Hunter Valley Operations South - Modification 5

Response to submissions

Prepared for HV Operations Pty Ltd | June 2017

This report formally responds to a letter from the NSW Department of Planning and Environment (DPE) dated 21 May 2017, requesting Coal & Allied address the issues raised during the public exhibition of the Environmental Assessment (EA) for the proposed modification. During the exhibition period (from 9 February to 10 March 2017) submissions were received from community organisations, individual members of the community, Singleton Council and other government agencies. These submissions, together with the DPE letter of request, are available on the DPE website:

Proposed indicative final landform and cross-section location
 HVO South Modification 5
 Response to submissions
 Figure 3.2

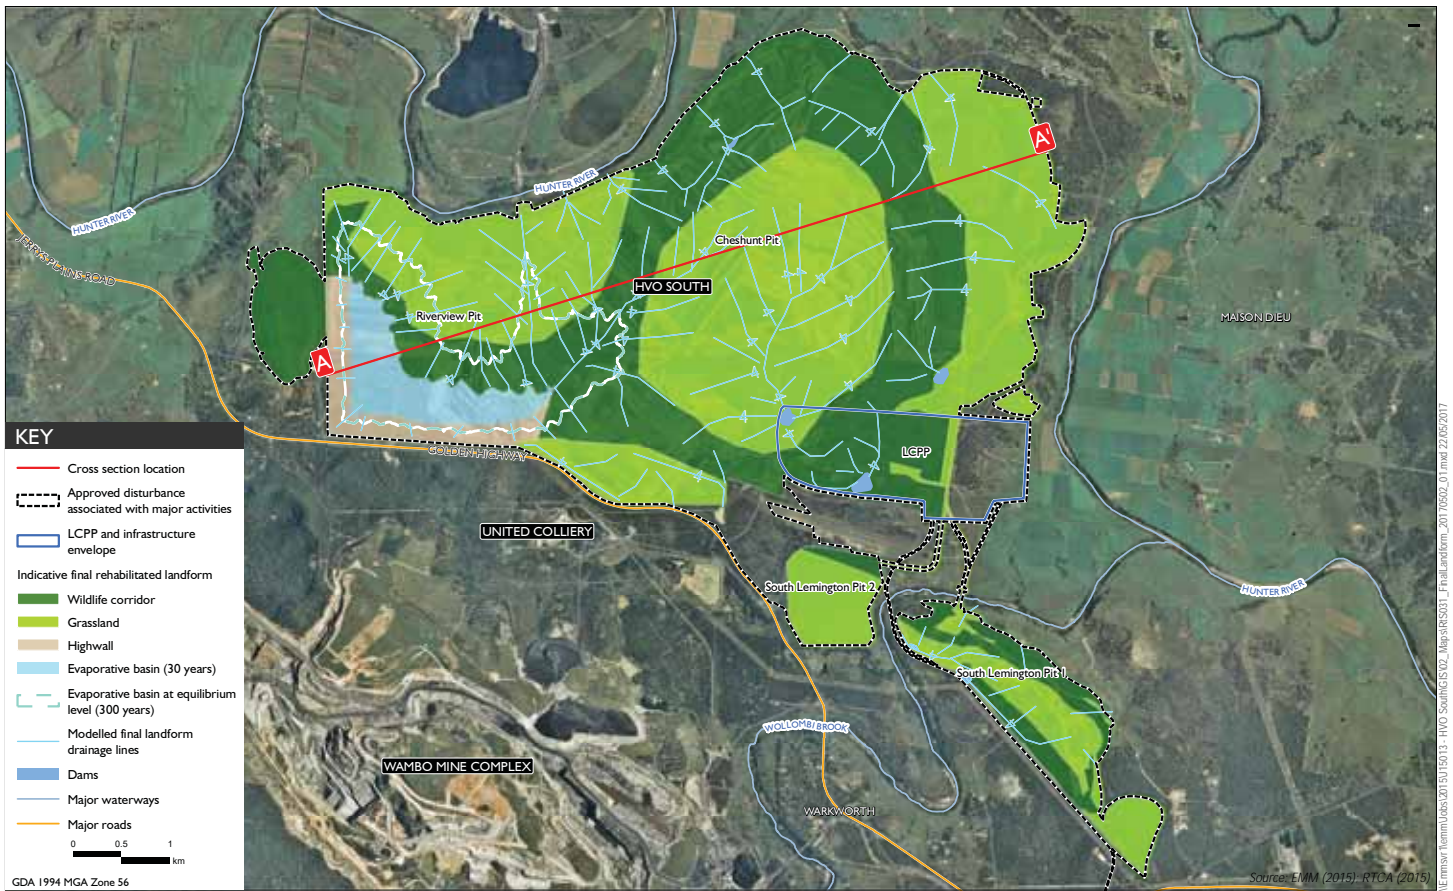
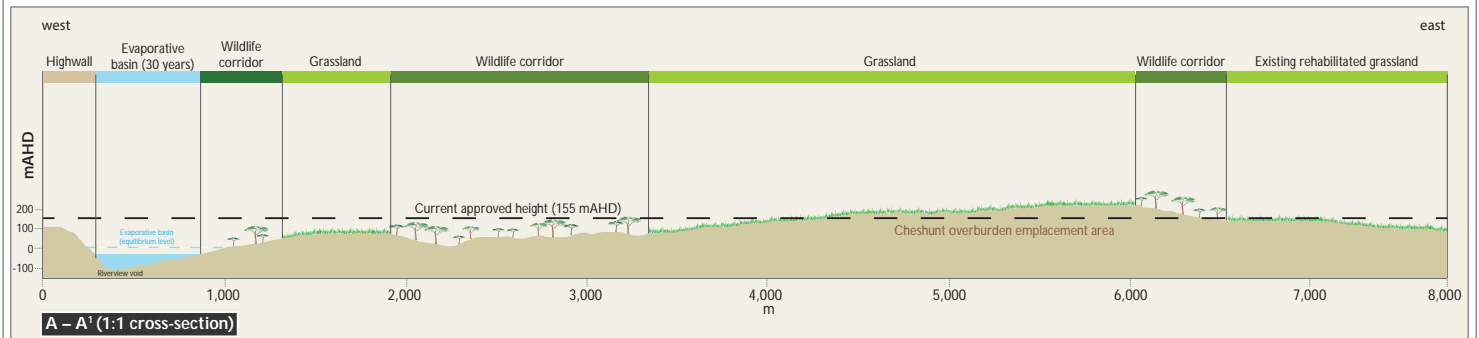
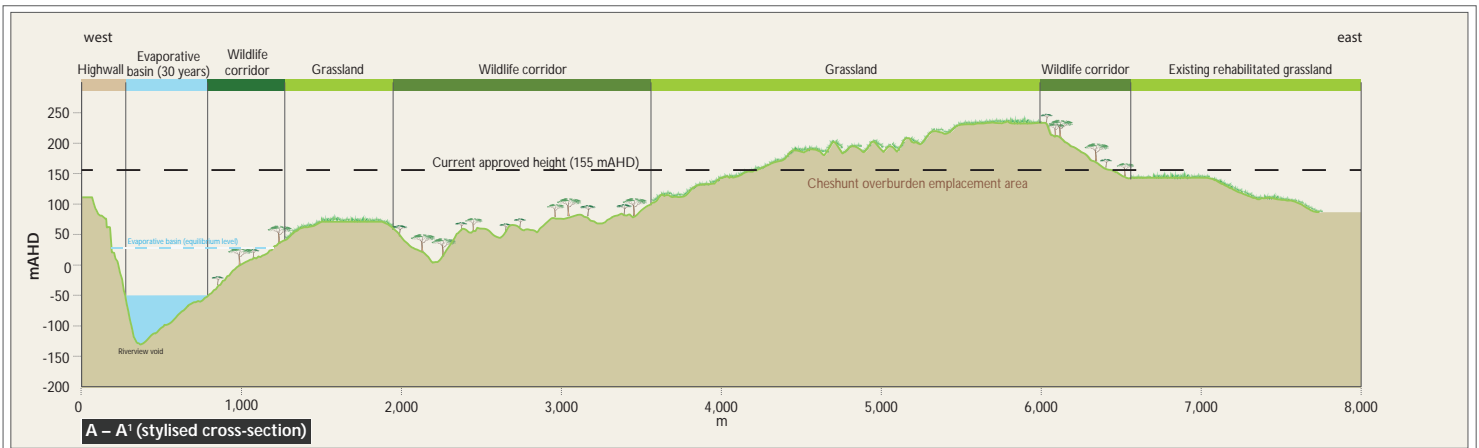
Figure 3.2 shows the proposed indicative final landform and provides a cross-section location which is shown in Figure 3.3. Figure 3.3 provides both the stylised cross-section (originally shown in the EA as Figure 13.2) and a 1:1 scaled cross-section to represent the proposed indicative final landform. The 1:1 scaled cross-section provides additional context to the micro-relief and final void slope angles. It demonstrates the low-wall and highwall slope angles as well as the height/depth in context to the overall disturbance footprint.

In summary, the slope angles of the highwall under the proposed modification are consistent with those of the currently approved mine plan. Importantly, the design of the final void prioritised a reduction in overall slope angle for the low-wall in order to increase the area of useable land available for sustainable agricultural practices (consistent with the requirements of the *Synoptic Plan – Integrated Landscapes for Coal Mine Rehabilitation for the Hunter Valley of NSW* (the Synoptic Plan) (Department of Mineral Resources 1999)) in the short, medium and long-term.

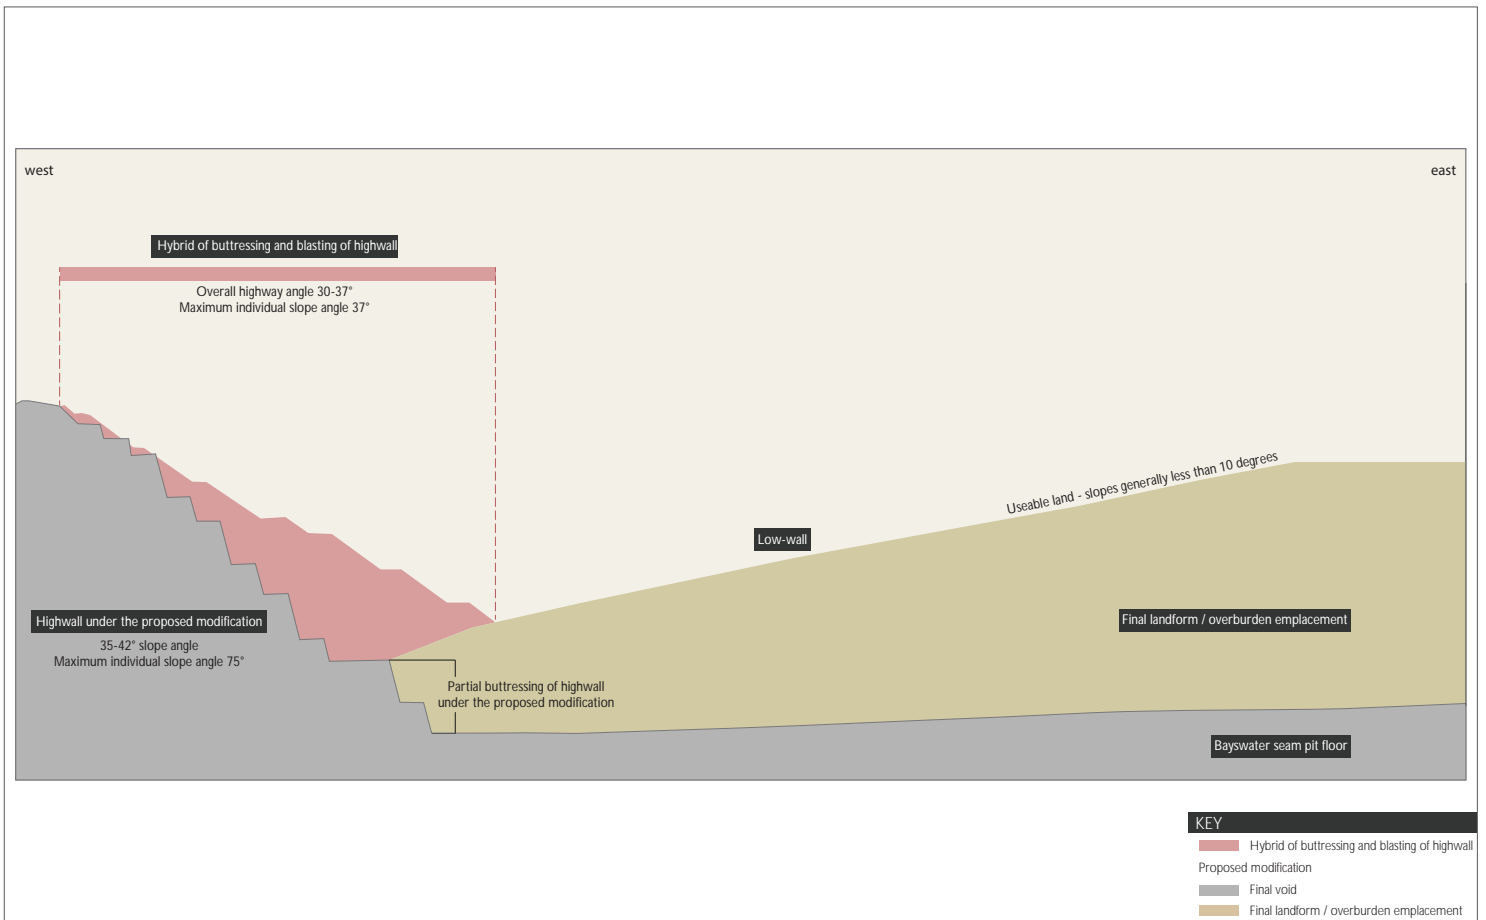
Figure 3.4 shows the highwall and final void under the proposed modification. This figure shows that the proposed modification already comprises a significant amount of buttressing above the pit floor and a number of safety benches on the exposed insitu highwall to achieve the desired overall 35 to 42 degree highwall slope angle, whilst also creating a gentler low-wall slope increasing the useable land available post-mining and reducing the surface catchment draining to the final void compared to the approved final landform.

It is considered that implementation of the available options to create a highwall of 37 degrees or less within the final void at Riverview Pit under the proposed modification is not viable due to the significant additional cost required to implement. Additionally, the increased noise, dust and visual amenity impacts on surrounding receptors and reduced final land use capability are inconsistent with the guiding design principles to avoid and minimise environmental impacts whilst maximising the areas available for post mining use.

Comparison of approved and proposed incremental 24 hr PM₁₀ concentrations
 HVO South Modification 5
 Response to submissions
 Figure 4.2

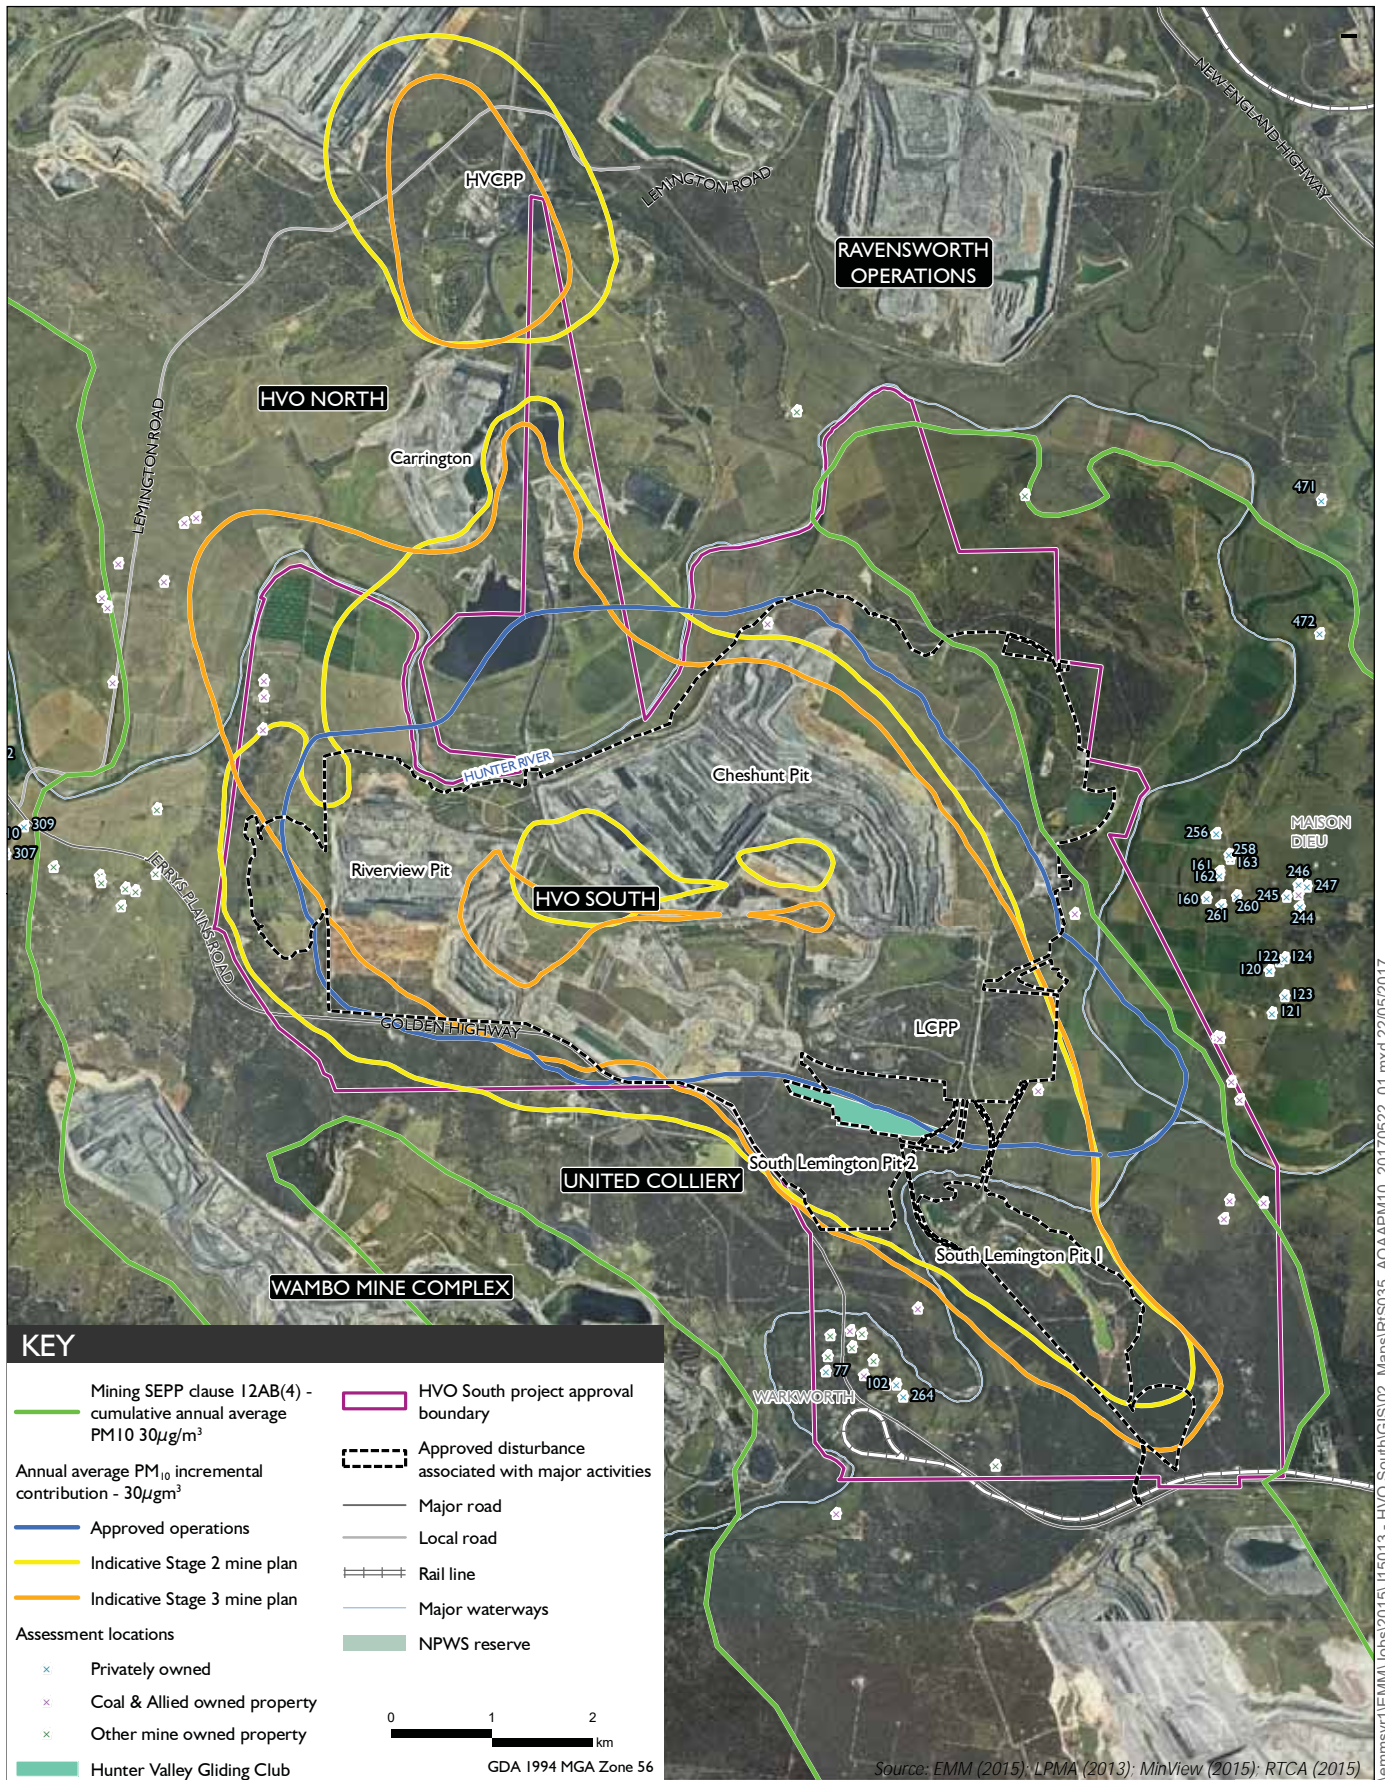
Coal & Allied recognises the Hunter Valley Gliding Club as a near neighbour. In response to its submission, we have updated the air quality modelling results in Figure 8.2 and Figure 8.3 of the EA to show the location of the Hunter Valley Gliding Club. These updated figures are included in Figures 4.2 and 4.3 of this RTS and have been provided to representatives of the Hunter Valley Gliding Club.
